# EL DORADO COUNTY

## DEPARTMENT OF TRANSPORTATION

**SUBJECT:** **Addendum No. 1**  
**Silver Springs Parkway Offsite (South Segment)**  
**Contract No. 4076, Project No. 78108**

SHEET  
**20R**  
OF **34**  
R.O. No. **76108**

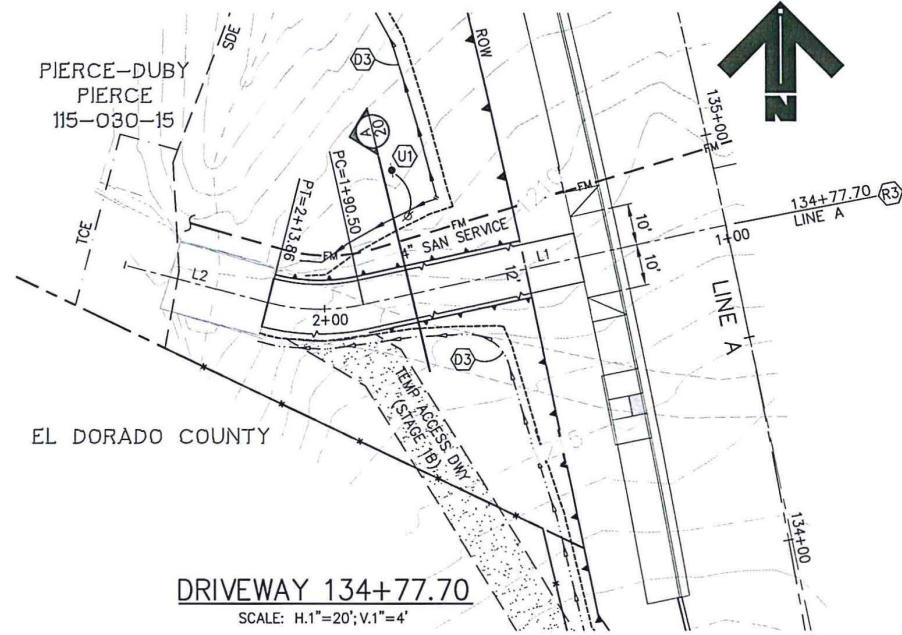
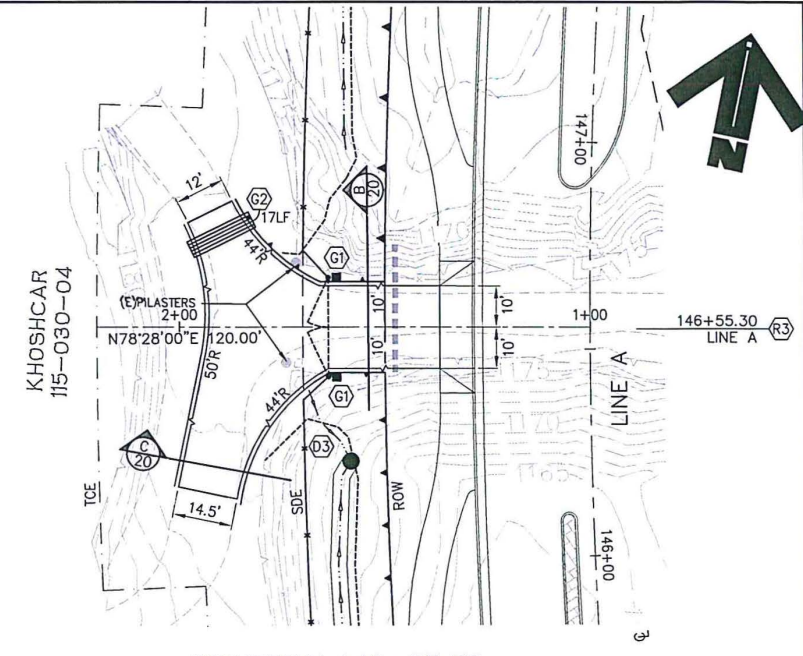
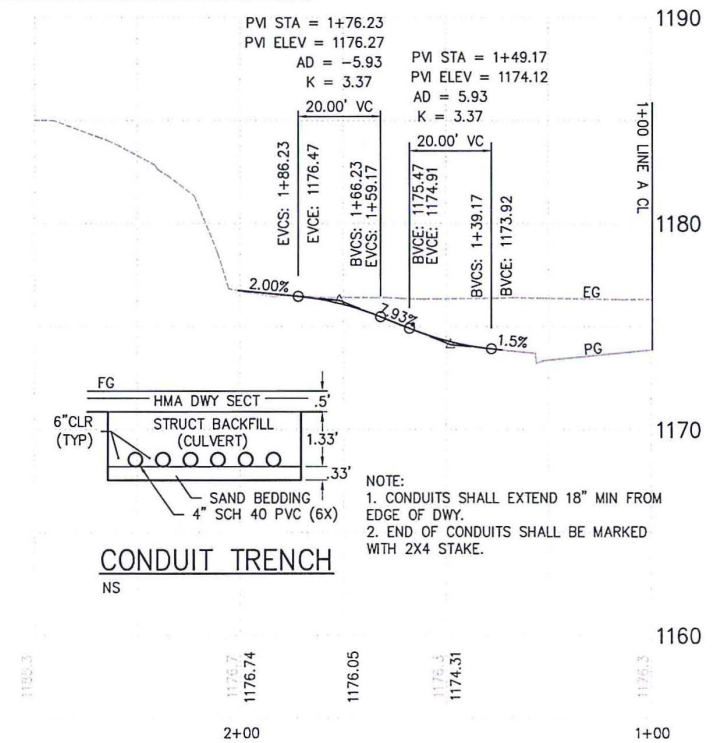
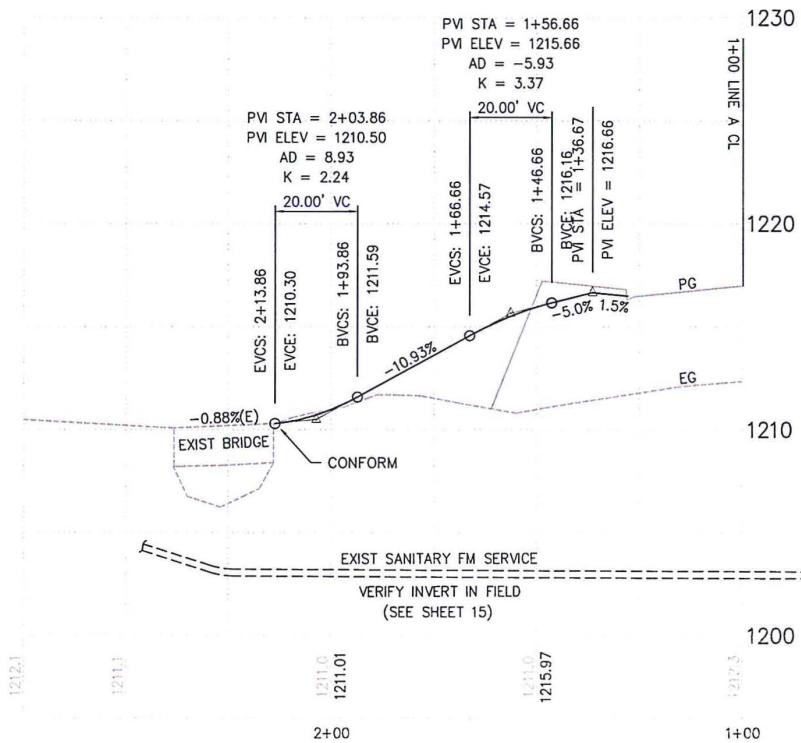
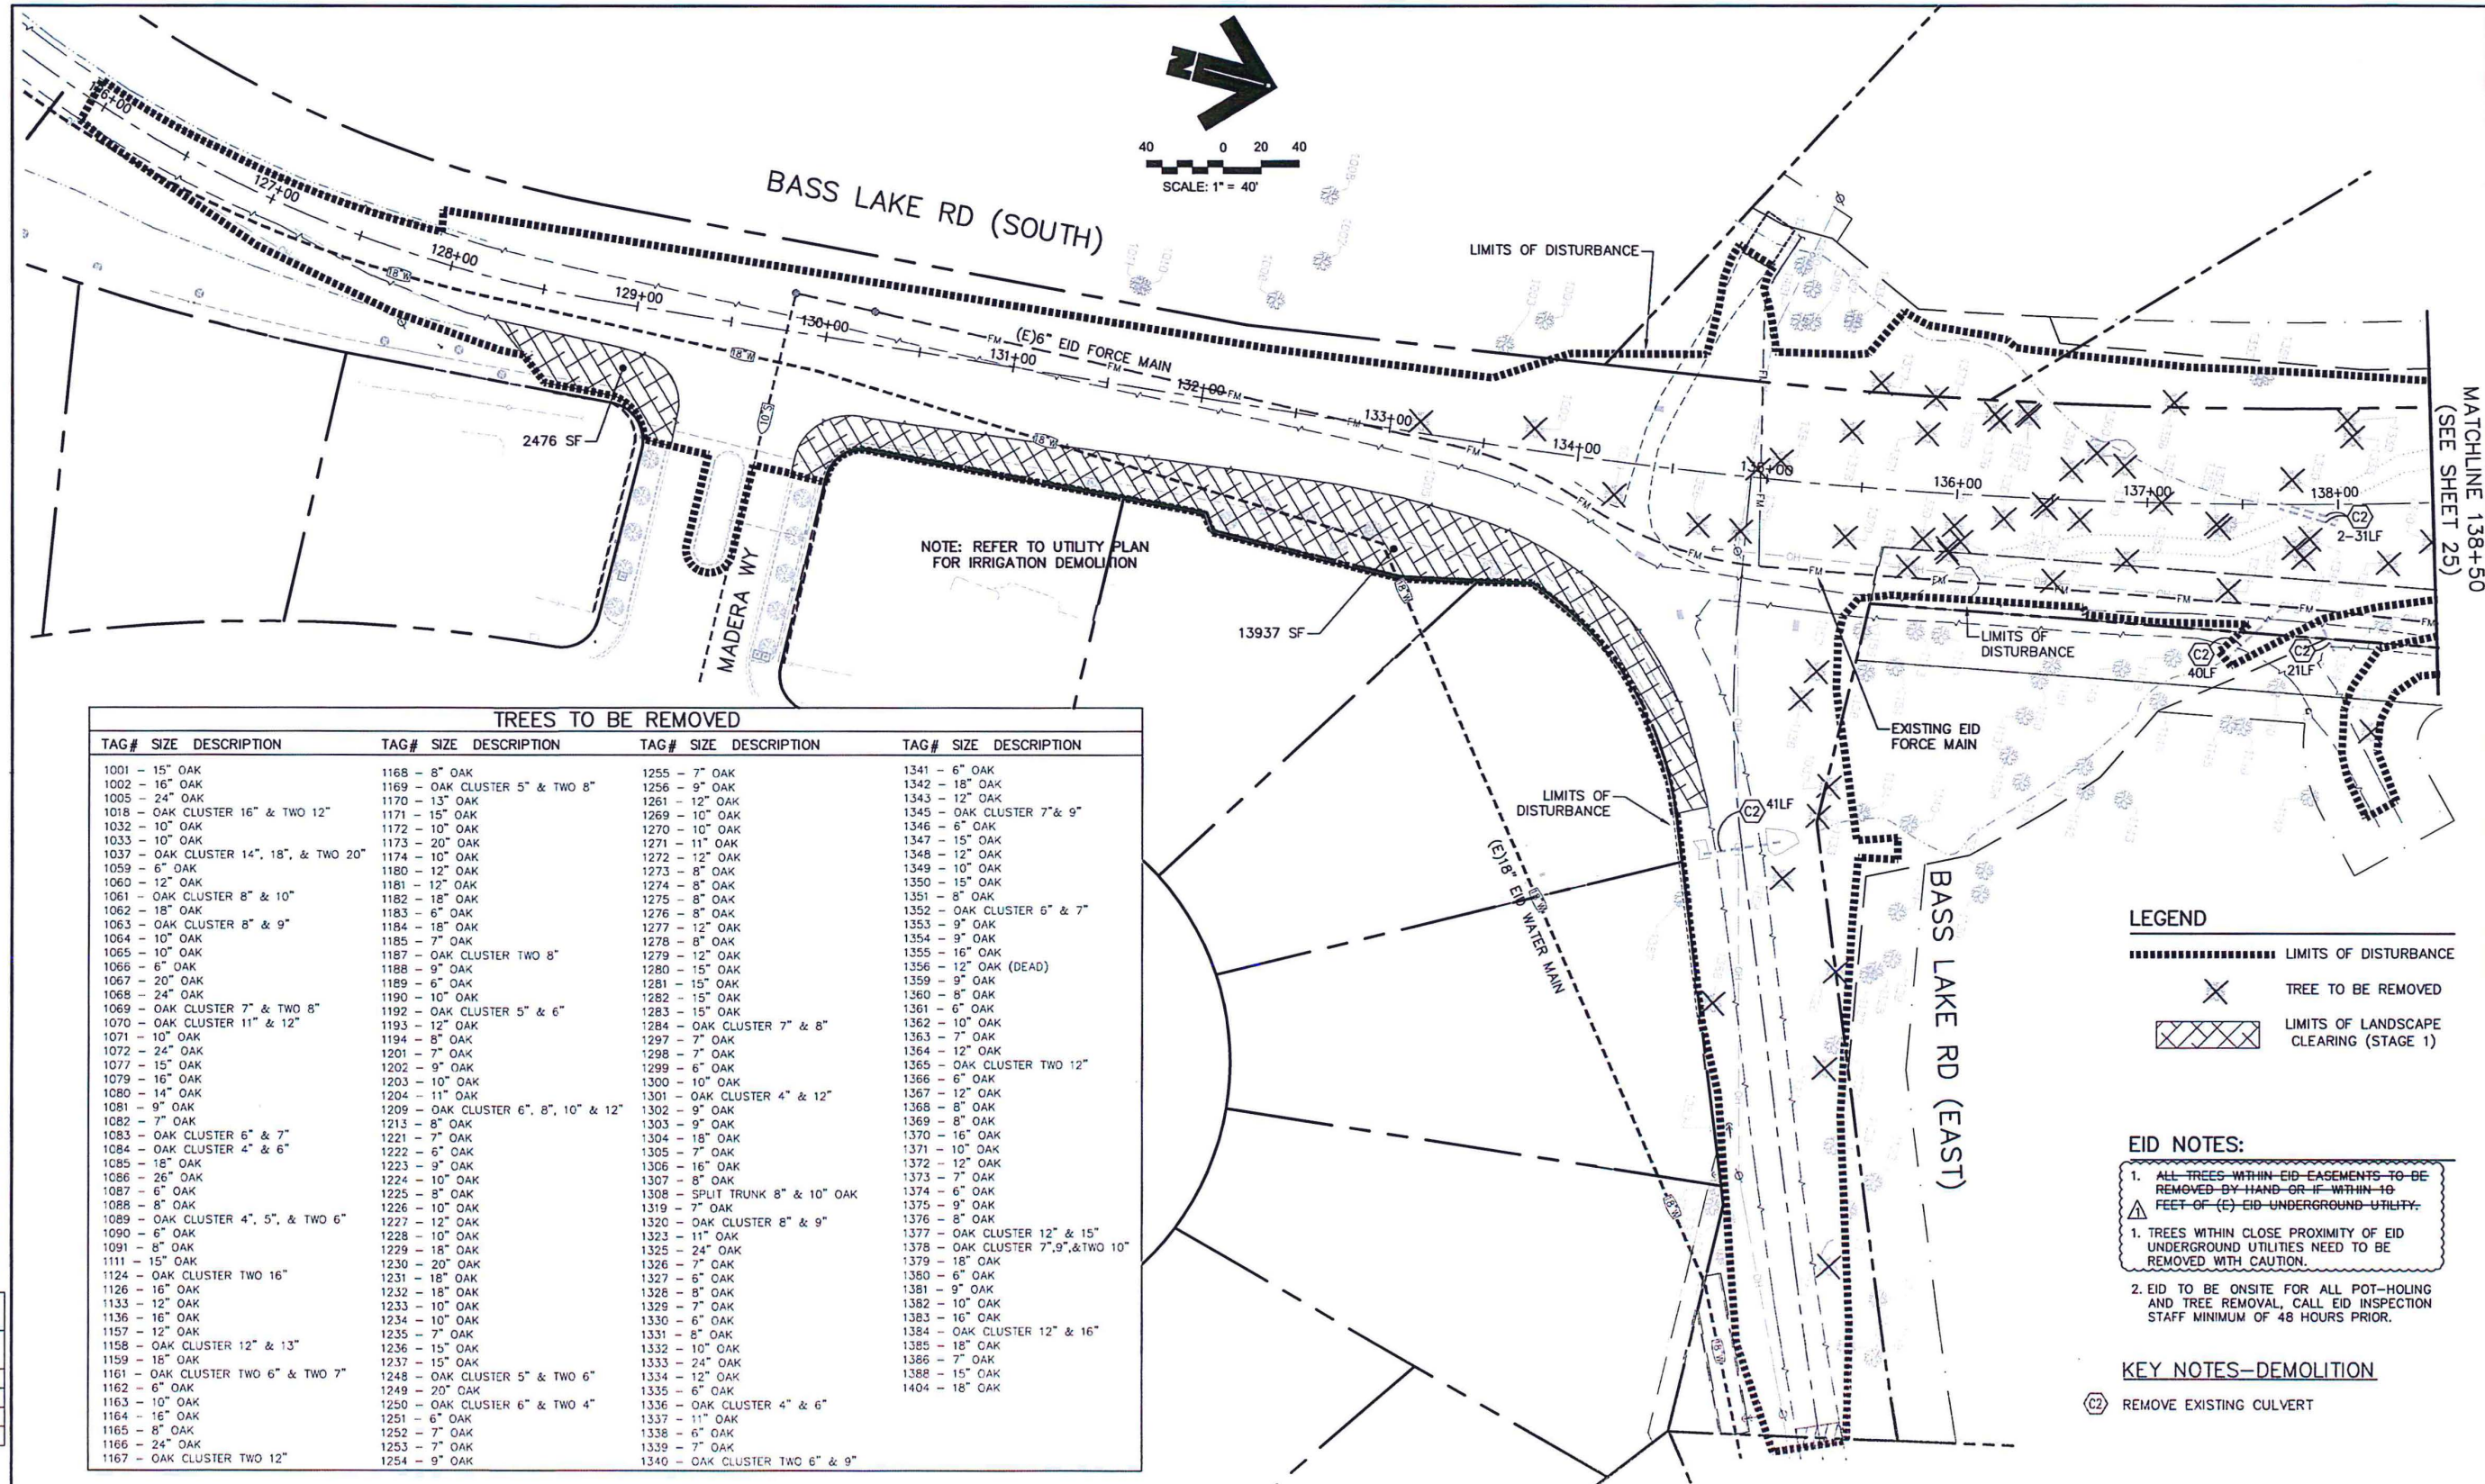
1.08	Page SP-48	<p>Bidders are instructed to <b>replace</b> section 15-1.03A in the special provisions with:</p> <p>The existing brick columns and gate at the driveway for APN 115-030-04 must be removed. The existing metal gate will be stored at a location designated by the Engineer on the property. The brick columns must be reconstructed per the executed right of way agreement to replace mail box and as shown on the plans. The gate must be reinstalled along with newly constructed brick columns and mailbox at Seller's new driveway entrance upon completion of the Project.</p>

- CONTRACTOR SHALL SALVAGE EXISTING STEEL GATE PANELS AND RETURN TO PROPERTY OWNER. PROPERTY OWNER SHALL BE RESPONSIBLE TO REINSTALL ACTUAL GATE PANELS.
- BRICK FACED COLUMNS SHALL BE RECONSTRUCTED IN-KIND. ORNAMENTAL TOPS MAY BE REUSED WHERE POSSIBLE.
- 6" DIAMETER STEEL GATE POSTS SHALL BE RECONSTRUCTED IN KIND. HINGES AND POST SPACING SHALL MATCH EXISTING PANELS FOR PROPER FUNCTION.
- ALL WORK WILL BE COORDINATED BY ENGINEER IN FIELD WITH PROPERTY OWNER.

- (G1) RELOCATE AND RECONSTRUCT EXISTING STEEL GATE POSTS AND BRICK COLUMNS IN-KIND. SEE NOTE THIS SHEET.
- (G2) INSTALL CONDUITS PER DETAIL THIS SHEET.
